**CITY OF BALTIMORE
DEPARTMENT OF GENERAL SERVICES
CAPITAL PROJECTS DIVISION**

Addendum No. 2

**For: CONTRACT NO. PRJ000889
HARFORD SENIOR RENOVATIONS & ENVELOPE UPGRADES**

GAS RISER DIAGRAM

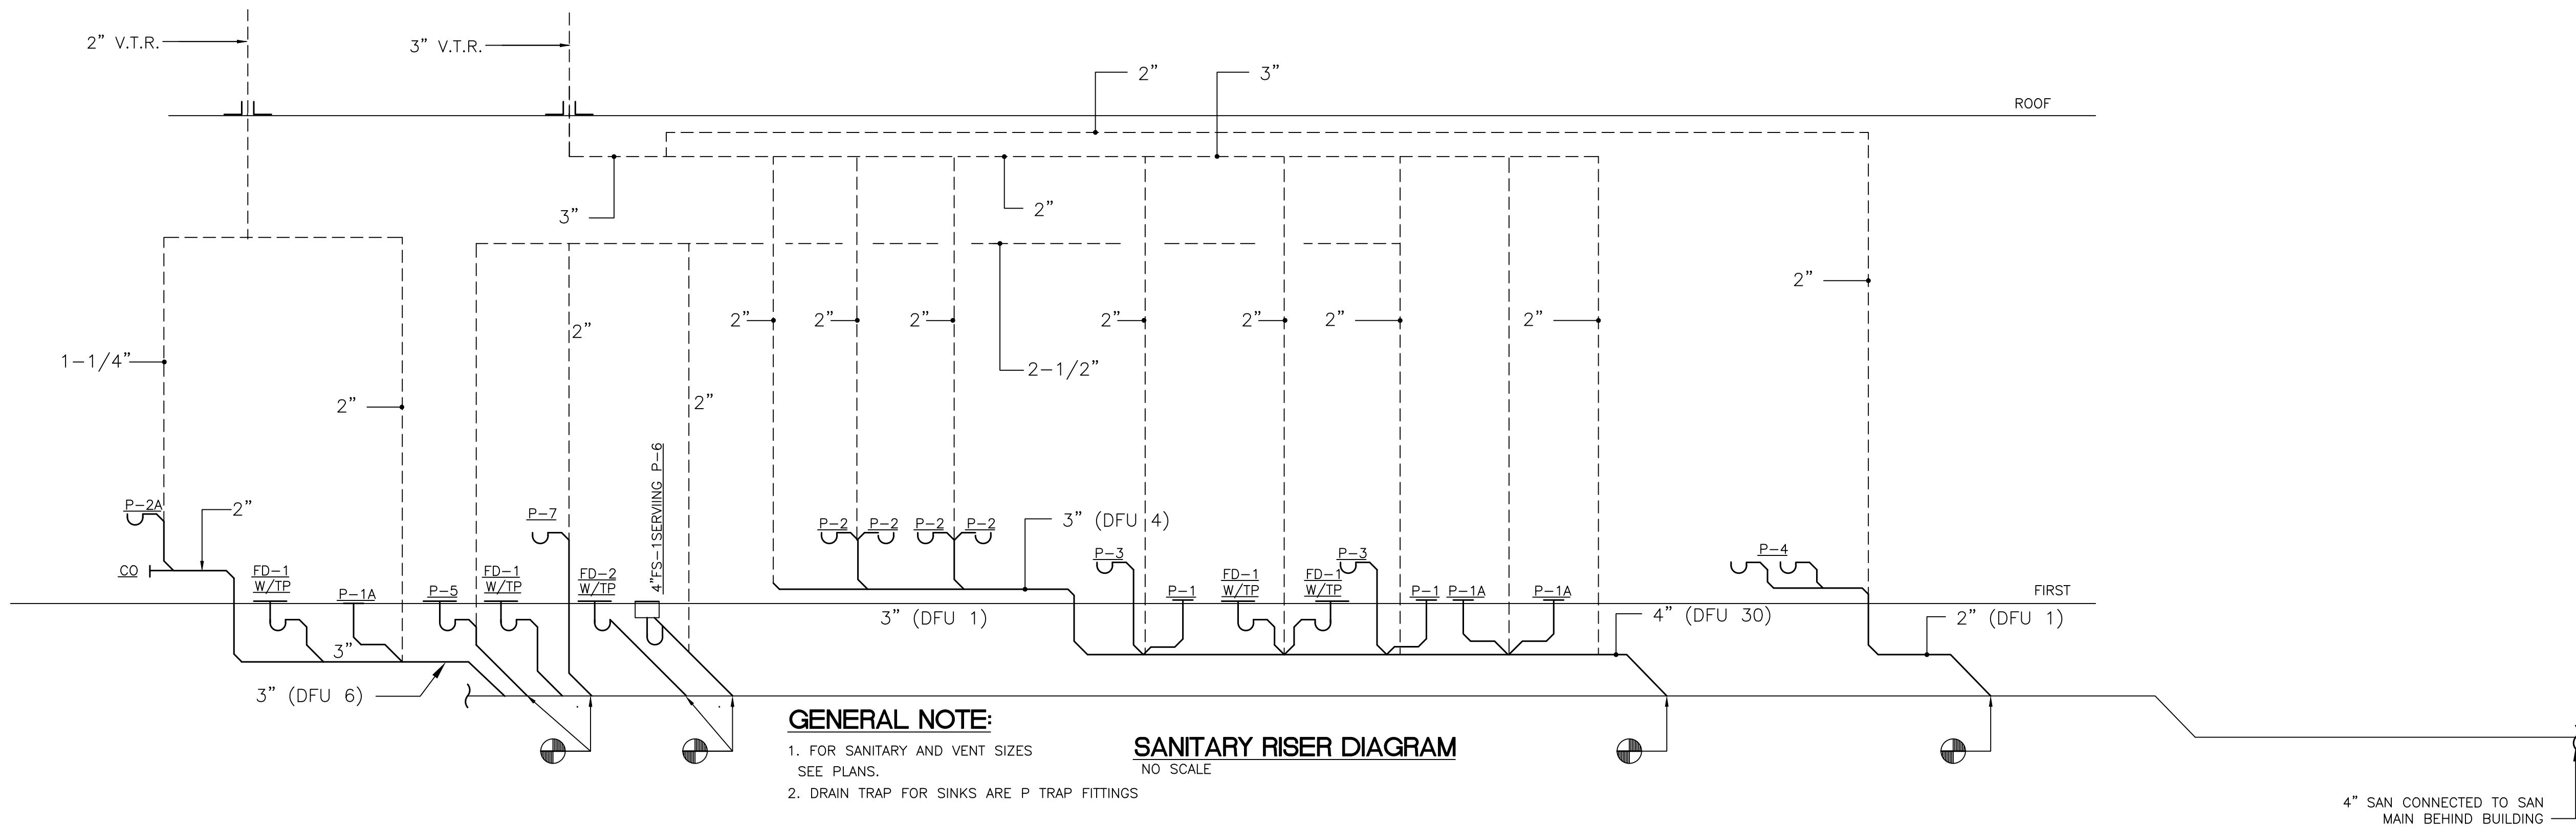
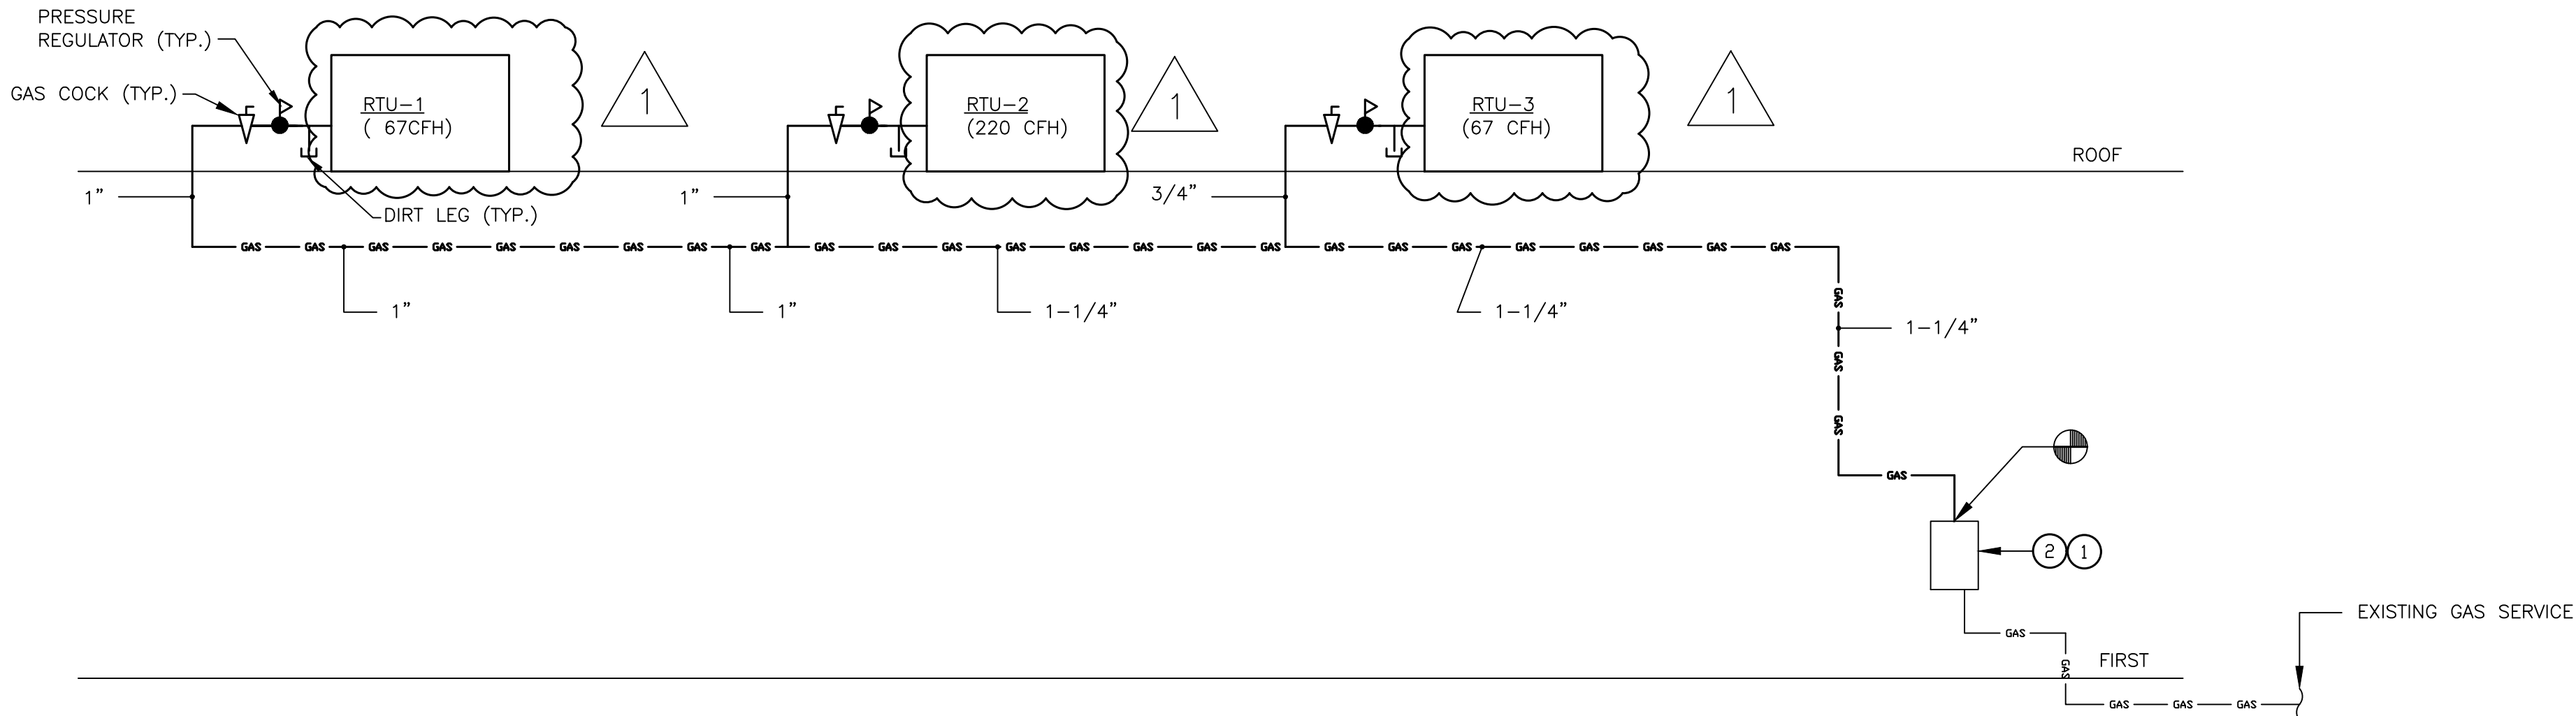
41. **(Q):** The domestic water riser diagram (dwg P300) shows the domestic water starting at 1-1/2" (at backflow preventor) but it also shows 2" tapping off to serve the bathrooms. Please confirm pipe sizes.
(A): Please see revised drawing P300 with updated domestic water sizing. Drawing has been revised to show a 2" line feeding the facility with a 1-1/2" line for bathroom distribution.

10. Drawing P300 "Plumbing Riser Diagrams"
REMOVE: Drawing P300 in its entirety
INSERT: Revised Drawing P300 in its entirety
NOTE: The gas riser diagram has been updated to match the heating capacity gas input noted on the packaged rooftop unit schedule on M200. Code reference has been updated to reference 2021 IFGC. Pipe sizes have been updated on the domestic water diagram.
